DART SERVICE INSTRUCTION

TO AMEND DRAWING D350-607 REV. F OR SUBSEQUENT APPROVED REVISION

THE PURPOSE OF THIS DART SERVICE INSTRUCTION (DSI), IS TO PROVIDE OPERATORS OF AS350 / 355 ROTORCRAFT EQUIPPED WITH DART D350-607-041 HELI UTILITY BASKETS WITH AN UPGRADE KIT TO REPLACE THE EXISTING LID PROP ARM WITH 2 GAS SPRINGS.

FIGURE 1
D350-607-141 AUTOMATIC LID OPENER INSTALLATION
 (BOTH ENDS)
D350-607-145 AUTOMATIC LID OPENER INSTALLATION
 (1 END ONLY)

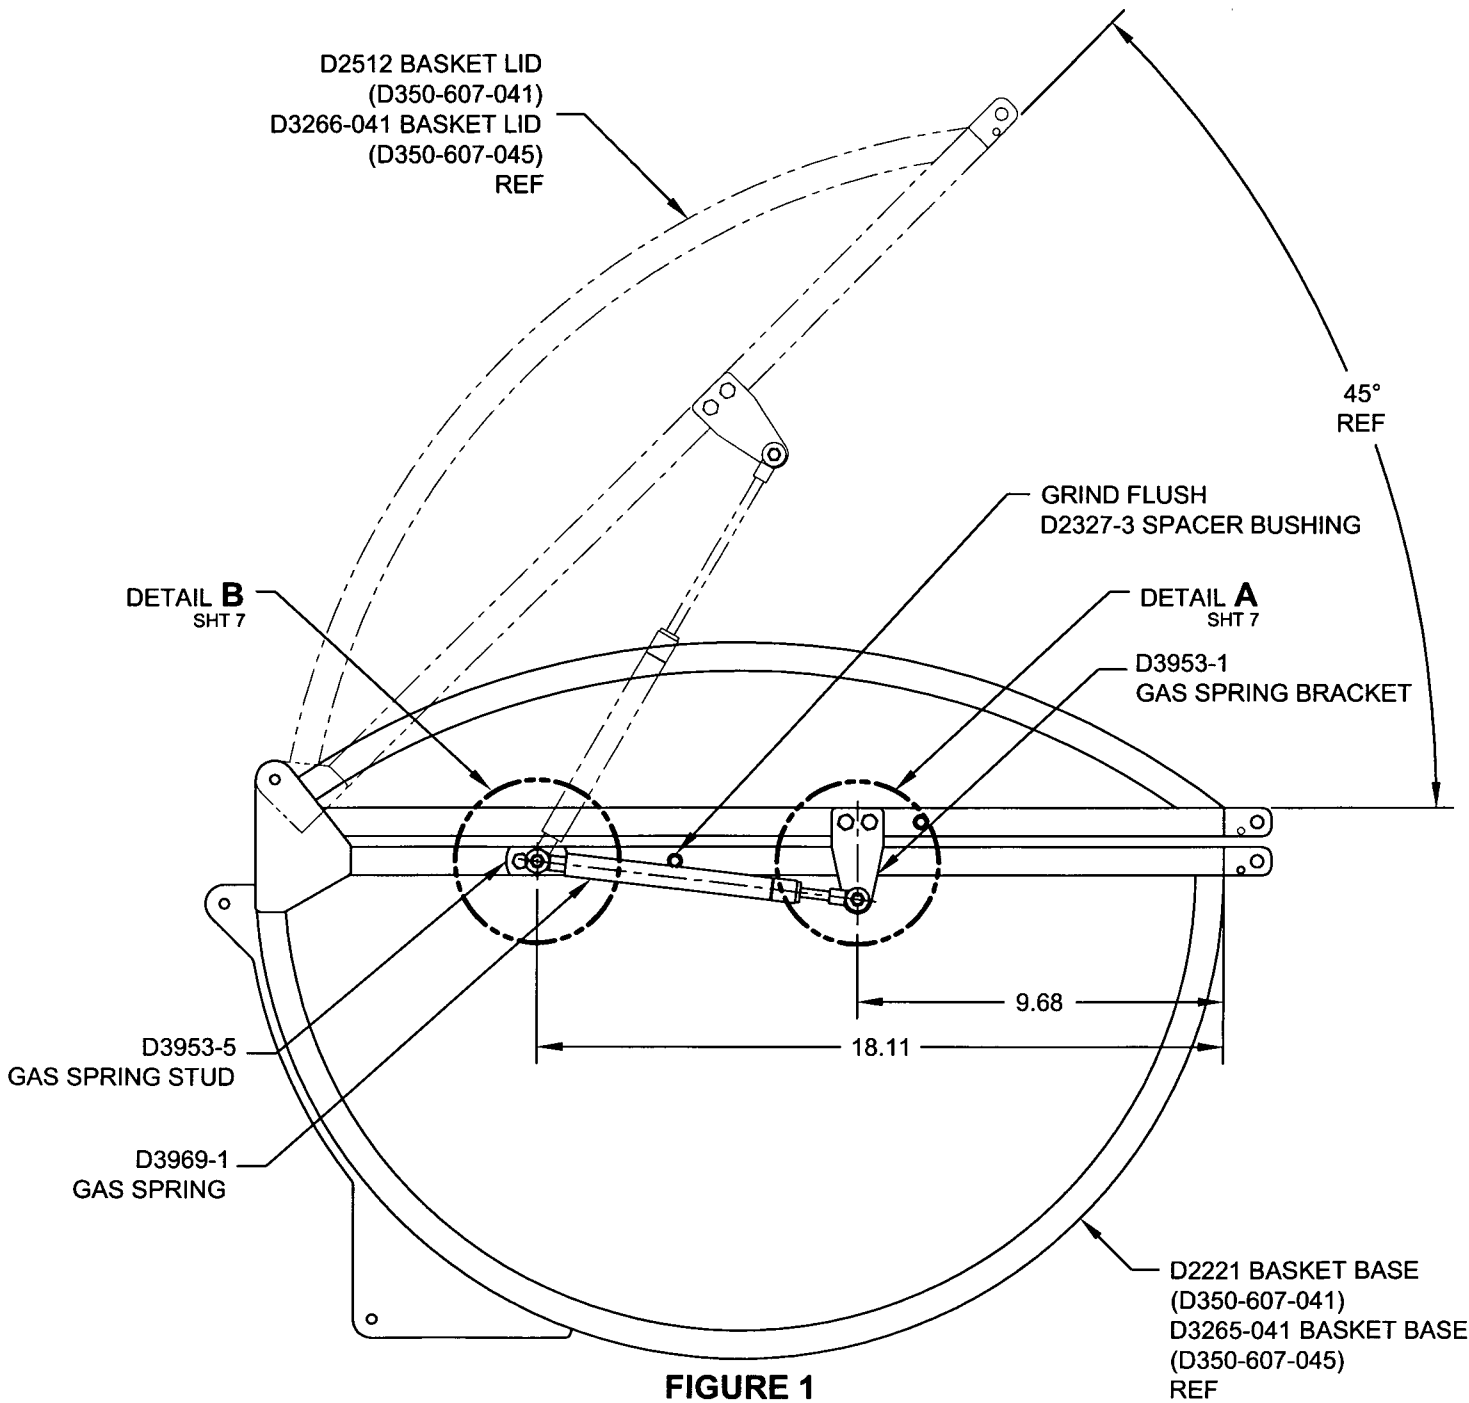
- 1) REMOVE THE D2332-041 PROP ARM.
 - 2) GRIND FLUSH THE D2327-3 SPACER BUSHING ON BOTH ENDS OF THE BASKET AS SHOWN IN FIGURE 1 (IT IS PERMISSIBLE TO GRIND ALL 4 SPACERS FLUSH). TOUCH UP PAINT PER ICA-D350-607 REV. 0 SECTION 5.1 ITEM 4.

- 3) LOCATE THE D3953-1 GAS SPRING BRACKET AS SHOWN IN FIGURE 1. TRIM STEEL MESH LOCALLY AS REQUIRED. TOUCH UP PAINT PER ICA-D350-607 REV. 0 SECTION 5.1 ITEM 4. TRANSFER MARK AND DRILL 2X Ø0.194 HOLES THRU THE BASKET LID SQUARE TUBE STRUCTURE AS SHOWN IN DETAIL A. INSTALL THE D3953-1 GAS SPRING BRACKET & D3953-13 GAS SPRING SPACER USING 2X AN3C16A BOLT, 2X NAS1149C0332R WASHER & 2X MS21043-3 NUT AS SHOWN IN VIEW E-E.

- 4) LOCATE THE D3953-5 GAS SPRING STUD AS SHOWN IN FIGURE 1. TRIM STEEL MESH LOCALLY AS REQUIRED. TOUCH UP PAINT PER ICA-D350-607 REV. 0 SECTION 5.1 ITEM 4. TRANSFER MARK AND DRILL 2X Ø0.194 HOLES THRU THE BASKET BASE SQUARE TUBE STRUCTURE AS SHOWN IN DETAIL B. FASTEN D3953-5 IAW VIEW F-F USING 2X AN3C11A BOLT, 2X NAS1149C0332R WASHER & 2X MS21043-3 NUT.

FIGURE 2

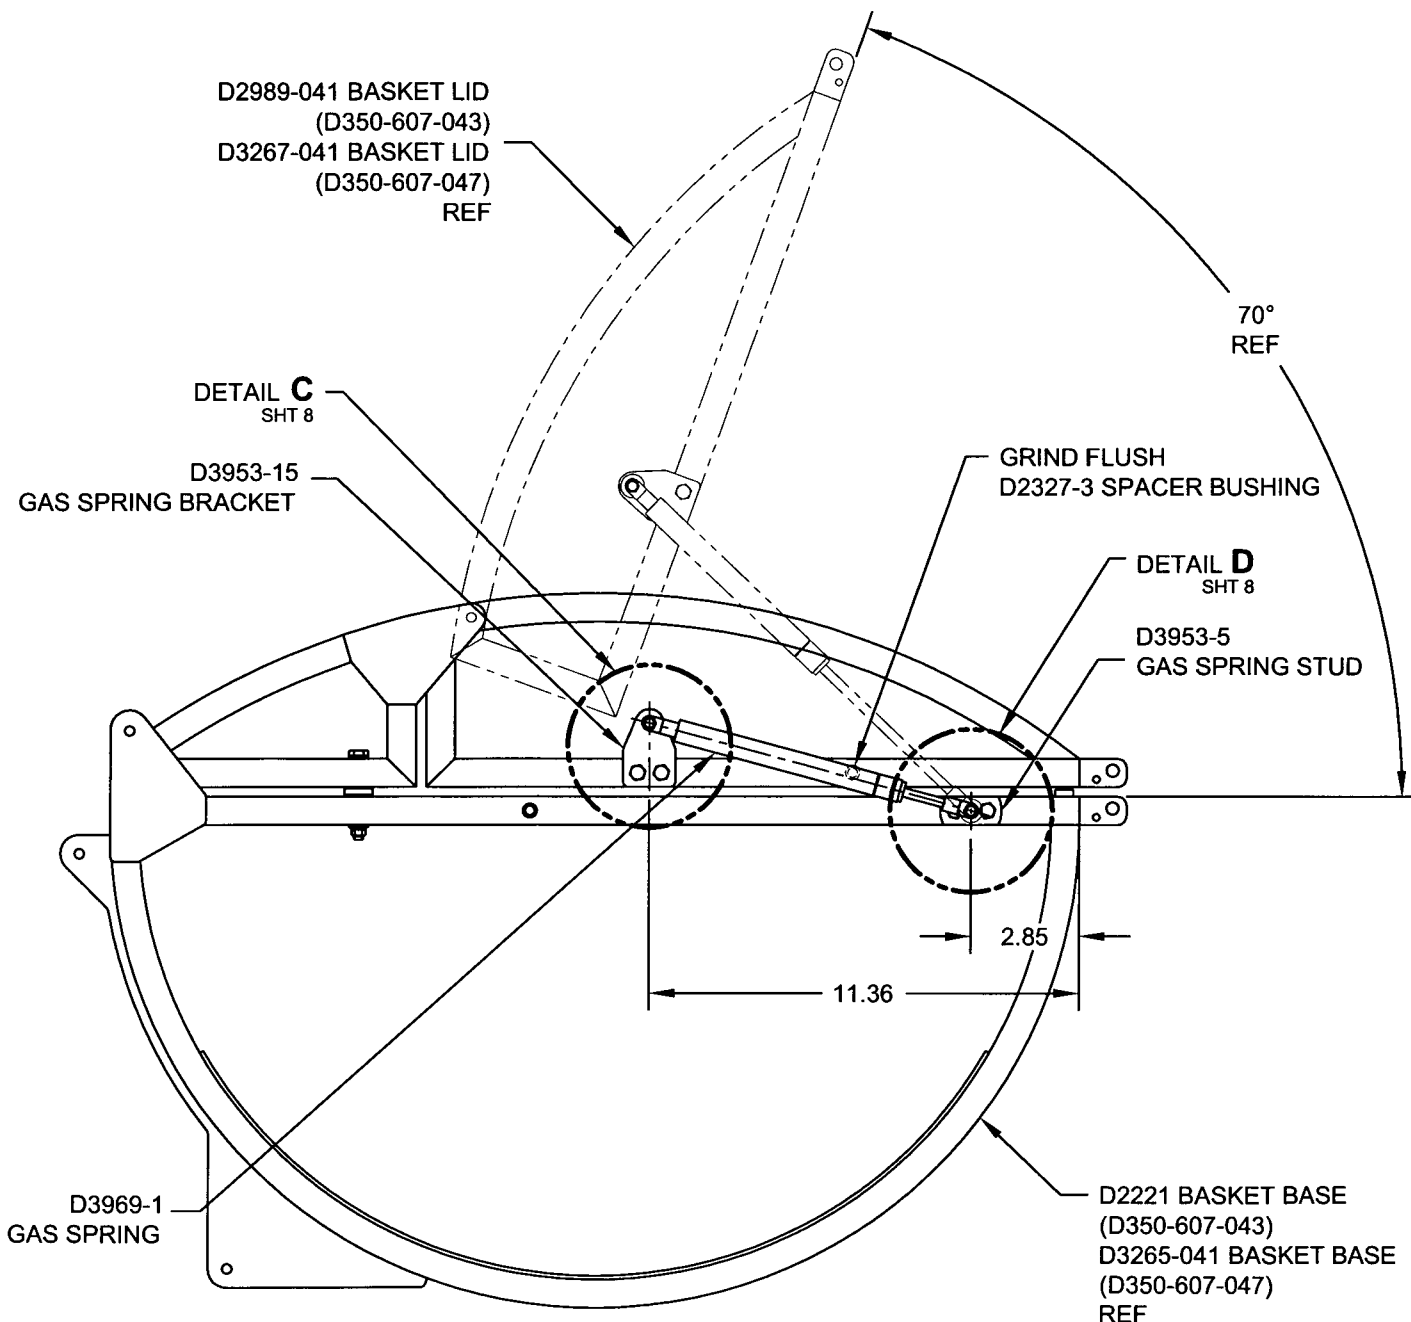
- 1) REMOVE THE D2332-041 PROP ARM.
 - 2) GRIND FLUSH THE D2327-3 SPACER BUSHING ON THE END OF THE BASKET WHERE THE LID OPENER IS BE INSTALLED AS SHOWN IN FIGURE 2 (IT IS PERMISSIBLE TO GRIND ALL 4 SPACERS FLUSH). TOUCH UP PAINT PER ICA-D350-607 REV. 0 SECTION 5.1 ITEM 4.

- 3) LOCATE THE D3953-15 GAS SPRING BRACKET AS SHOWN IN FIGURE 2. TRIM STEEL MESH LOCALLY AS REQUIRED. TOUCH UP PAINT PER ICA-D350-607 REV. 0 SECTION 5.1 ITEM 4. TRANSFER MARK AND DRILL 2X Ø0.194 HOLES THRU THE BASKET LID SQUARE TUBE STRUCTURE AS SHOWN IN DETAIL C. INSTALL THE D3953-15 GAS SPRING BRACKET & D3953-17 GAS SPRING SPACER USING 2X AN3C15A BOLT, 2X NAS1149C0332R WASHER & 2X MS21043-3 NUT AS SHOWN IN VIEW G-G.

- 4) LOCATE THE D3953-5 GAS SPRING STUD AS SHOWN IN FIGURE 2. TRIM STEEL MESH LOCALLY AS REQUIRED. TOUCH UP PAINT PER ICA-D350-607 REV. 0 SECTION 5.1 ITEM 4. TRANSFER MARK AND DRILL 2X Ø0.194 HOLES THRU THE BASKET BASE SQUARE TUBE STRUCTURE AS SHOWN IN DETAIL D. INSTALL 2X AN3C11A BOLT, 2X NAS1149C0332R WASHER & 2X MS21043-3 NUT AS SHOWN IN VIEW H-H. INSTALL THE ROD END OF THE D3969-1 GAS SPRING ONTO THE D3953-3 GAS SPRING STUD USING 1X D3953-9 GAS SPRING WASHER, 1X NAS1149C0432R WASHER, 1X AN310-4 CASTELATTED NUT & 1X MS24665-212 COTTER PIN AS SHOWN IN VIEW H-H. INSTALL COTTER PIN PER MS33540 OR AC43.13 CHAPTER 7-127.

VIEW F-F

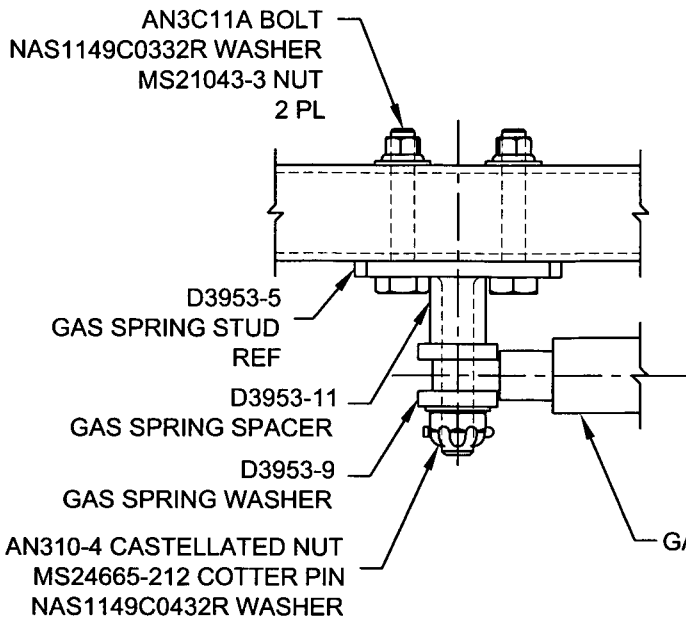
- 5) INSTALL 1X D3953-11 GAS SPRING SPACER ONTO THE D3953-5 STUD AS SHOWN IN VIEW F-F. INSTALL THE LARGE END OF THE D3969-1 GAS SPRING SPRING ONTO THE D3953-5 GAS SPRING STUD AND FASTEN IN PLACE USING 1X D3953-9 GAS SPRING WASHER, 1X NAS1149C0432R WASHER, 1X AN310-4 CASTELATTED NUT & 1X MS24665-212 COTTER PIN AS SHOWN IN VIEW F-F. INSTALL COTTER PIN PER MS33540 OR AC43.13 CHAPTER 7-127.

VIEW E-E

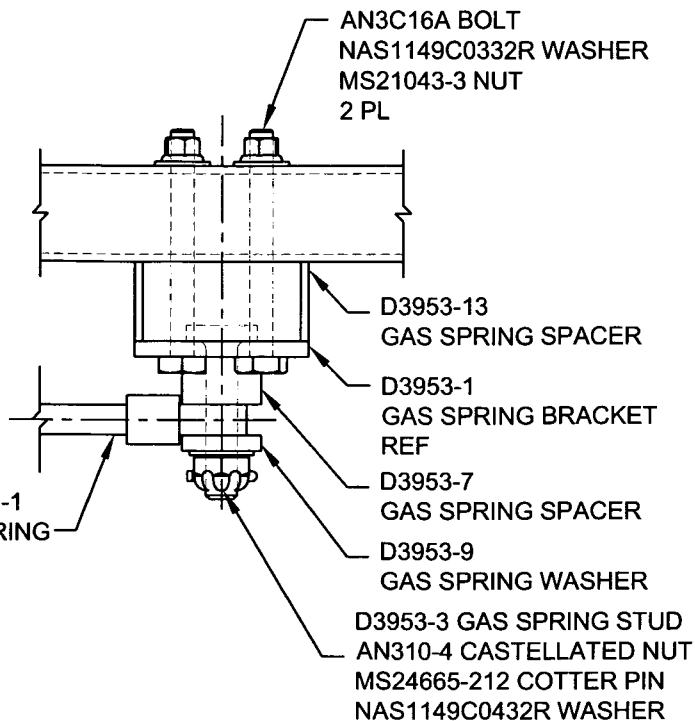
- 6) INSERT THE D3953-3 GAS SPRING STUD INTO THE D3953-1 GAS SPRING BRACKET & INSERT THE D3953-7 GAS SPRING SPACER ONTO THE D3953-3 GAS SPRING AS SHOWN IN VIEW E-E. RAISE THE BASKET LID AND INSTALL THE ROD END OF THE D3969-1 GAS SPRING ONTO THE D3953-3 GAS SPRING STUD USING 1X D3953-9 GAS SPRING WASHER, 1X NAS1149C0432R WASHER, 1X AN310-4 CASTELATTED NUT & 1X MS24665-212 COTTER PIN AS SHOWN IN VIEW E-E. INSTALL COTTER PIN PER MS33540 OR AC43.13 CHAPTER 7-127.

VIEW G-G

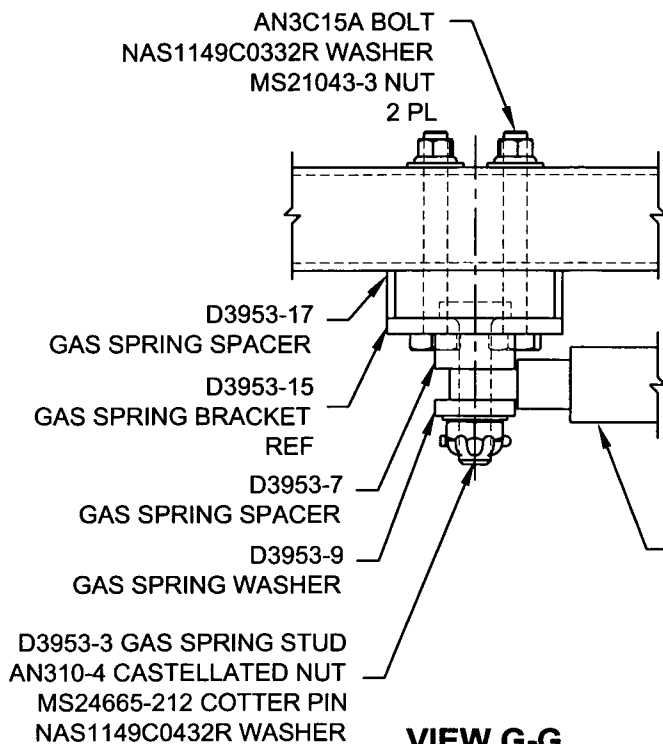
- 5) INSERT THE D3953-3 GAS SPRING STUD INTO THE D3953-15 GAS SPRING BRACKET & INSERT THE D3953-7 GAS SPRING SPACER ONTO THE D3953-3 GAS SPRING STUD AS SHOWN IN VIEW G-G. RAISE THE BASKET LID AND INSTALL THE D3969-1 GAS SPRING ONTO THE D3953-3 GAS SPRING STUD AND FASTEN IN PLACE USING 1X D3953-9 GAS SPRING WASHER, 1X NAS1149C0432R WASHER, 1X AN310-4 CASTELATTED NUT & 1X MS24665-212 COTTER PIN AS SHOWN IN VIEW G-G. INSTALL COTTER PIN PER MS33540 OR AC43.13 CHAPTER 7-127.
